STAFF REPORT: 11/8/2023 MEETING
APPLICATION NUMBER: HDC2023-00049
ADDRESS: 8066 KERCHEVAL
HISTORIC DISTRICT: WEST VILLAGE
APPLICANT: TADD HEIDGERKEN/ET AL COLLABORATIVE
DATE OF PROVISIONALLY COMPLETE APPLICATION: 10/16/2023
DATE OF STAFF VISIT: 10/26/2023

SCOPE OF WORK: RECONSTRUCT STOREFRONTS, ADD ENTRYWAYS

Proposed east elevation

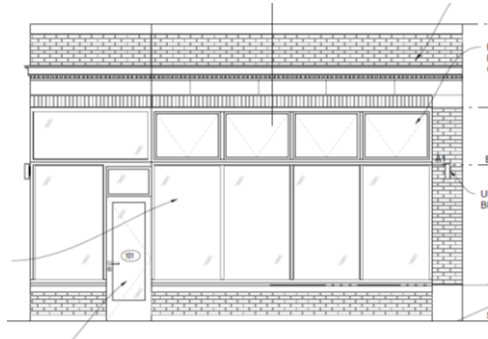
This storefront currently includes three glazed panels and an inset doorway. The project proposes to decrease the width of this storefront opening by removing the current inset doorway, installing a new aluminum storefront which includes two glazed panels, and infilling the remaining opening with brick

- The proposed replacement of the historic wood transoms and associated trim; beadboard ceilings; beadboard knee wall at the east façade's central storefront inset entry; wood trim at the side of the storefront windows; doors, transom and associated trim at the inset storefront entrances.
- The partial infilling of the storefront opening at the east elevation, which will eliminate the inset doorway and reduce the width of the storefront

Current conditions

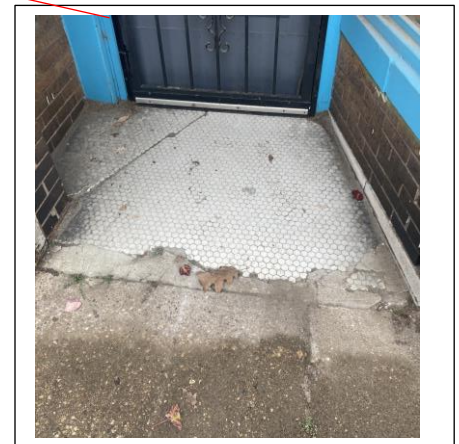
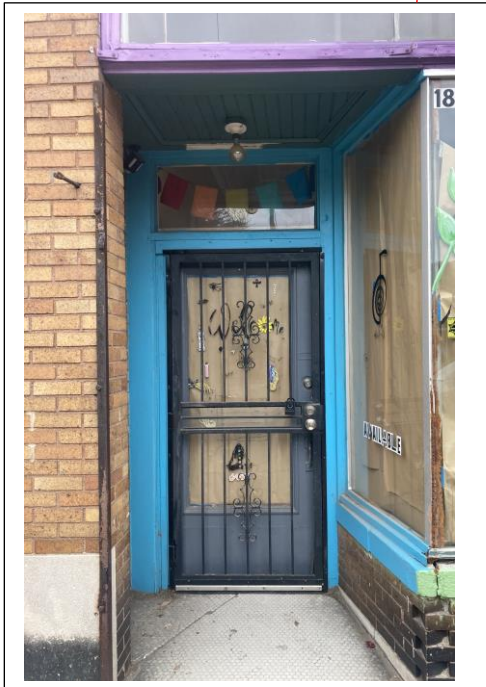
This formerly inset entrance will be bricked in, reducing the width of the storefront

These storefronts, to include wood transoms and trim, wood doors and associated trim/casing, and aluminum windows with wood trim will be replaced with new aluminum storefronts. The existing wood beadboard ceilings will also be removed.

This window, door, and brick below will be removed and the opening infilled with new brick, thus reducing the width of the current storefront opening and the inset opening

This door will be removed, and the opening infilled with brick. The transom will be replaced with a new aluminum transom.

A new single wood door with operable transom will be added at this location

Door at side/east elevation, north storefront that will be removed and opening infilled with brick

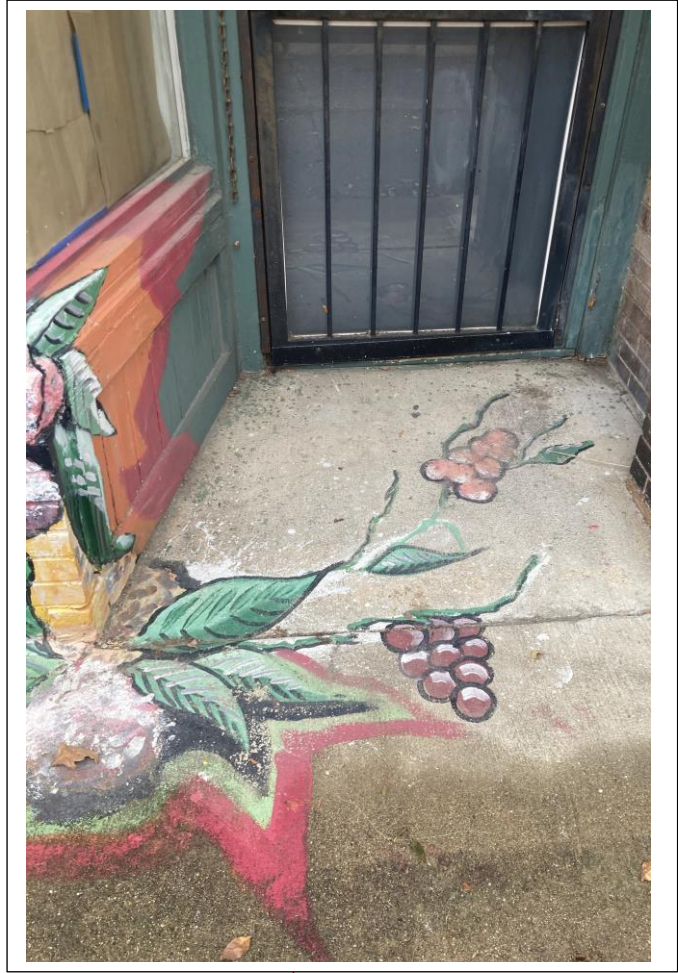
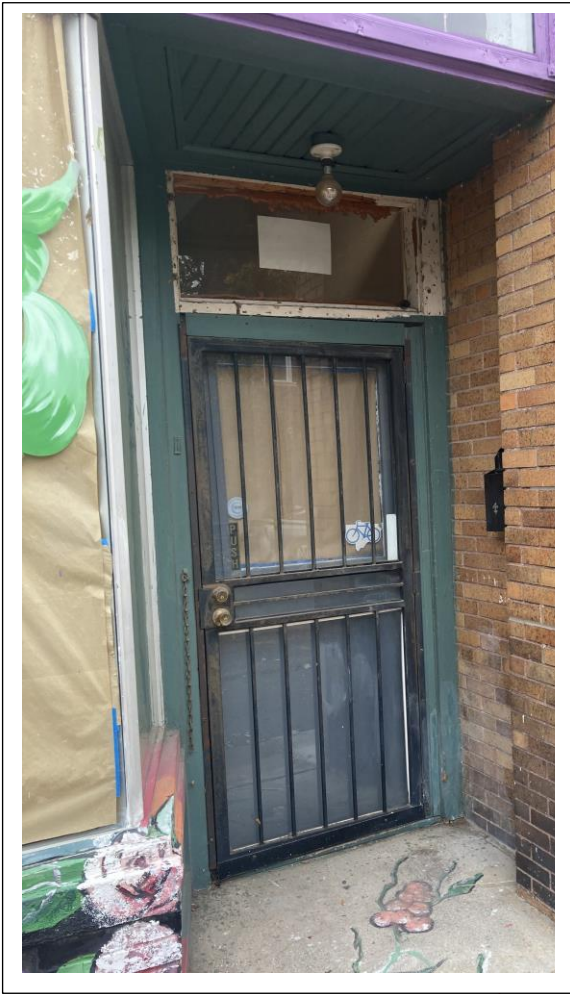
Primary storefront proposed for replacement with new aluminum storefront. Wood doors, aluminum windows, wood trim, wood transom, and penny tile will be removed.
